UNITED STATES PATENT AND TRADEMARK OFFICE

APPLICATION NO.	FILING DATE	FIRST NAMED INVENTOR	ATTORNEY DOCKET NO.	CONFIRMATION NO.
10/630,748	07/31/2003	Takeshi Tsubouchi	033528-006	9932
21839	7590	11/01/2005		
BUCHANAN INGERSOLL PC (INCLUDING BURNS, DOANE, SWECKER & MATHIS) POST OFFICE BOX 1404 ALEXANDRIA, VA 22313-1404			EXAMINER MENDOZA, MICHAEL G	
			ART UNIT	PAPER NUMBER
			3731

Office Action Summary	Application No. 10/630,748	Applicant(s) TSUBOUCHI, TAKESHI	
	Examiner Michael G. Mendoza	Art Unit 3731

DETAILED ACTION

Inventor
 by Adolph C. Recker
 Seymour, Earle & Nichols
 Attorneys

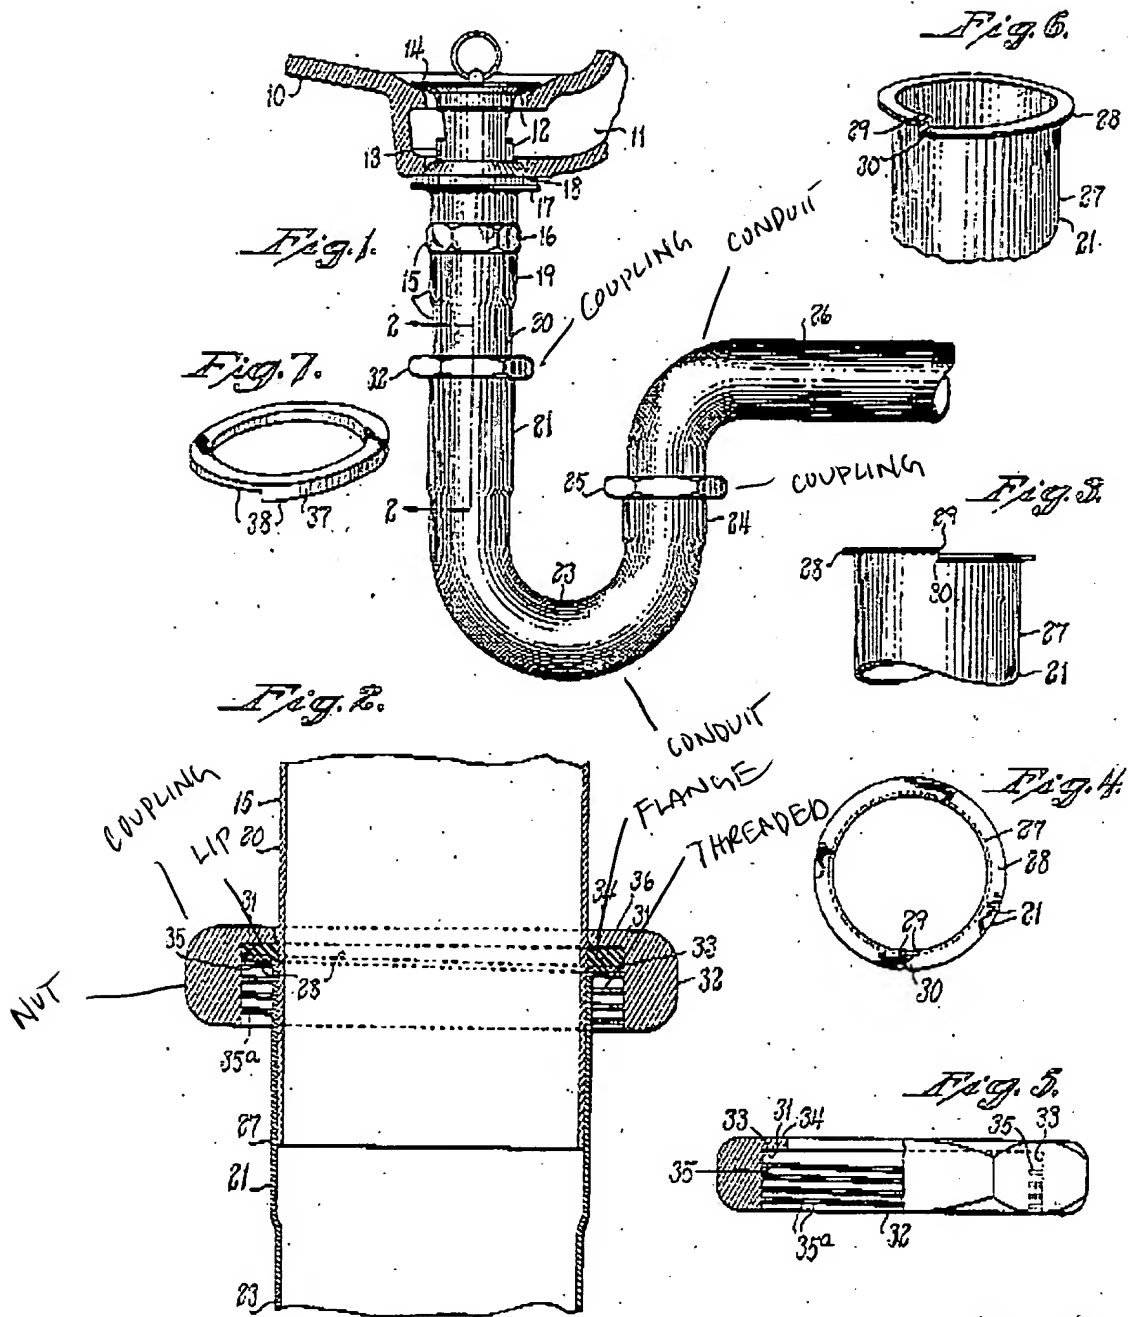
3. Claims 1, 3, 5-9, and 22 are rejected under 35 U.S.C. 102(b) as being anticipated by Recker 2210178.

4. ~~Brophy~~ ^{Recker} teaches a conduit assembly, the conduit assembly comprising: a conduit, the conduit including a first curved conduit and a second curved conduit; a first coupling (slip-joint), the first coupling being movable between a rotatable position and a fixed position; and a second coupling (slip-joint) for attaching, the second coupling being movable between a rotatable position and a fixed position; wherein the first and second curved conduits are rigid; wherein the conduit is circular in cross-section; wherein the first coupling comprises a first rotatable nut, the first rotatable nut being movable

between a rotatable position and a fixed position; wherein the first rotatable nut engages a correspondingly threaded inflow port; wherein the second coupling comprises a second rotatable nut, the second rotatable nut being movable between a rotatable position and a fixed position; wherein the second rotatable nut engages the second end of the first curved conduit, the second end of the first curved conduit being correspondingly threaded; wherein the second rotatable nut includes a lip for engaging the first end of the second curved conduit, the first end of the second conduit including a flange; and wherein the conduit defines a predetermined diameter, thereby maintaining the substantially continuous flow path between the first curved conduit and the second curved conduit. Slip-joint are of a well know construction. As evidenced by Little 2302617, the loosening of a nut in a slip-joint would allow rotation of the conduits.
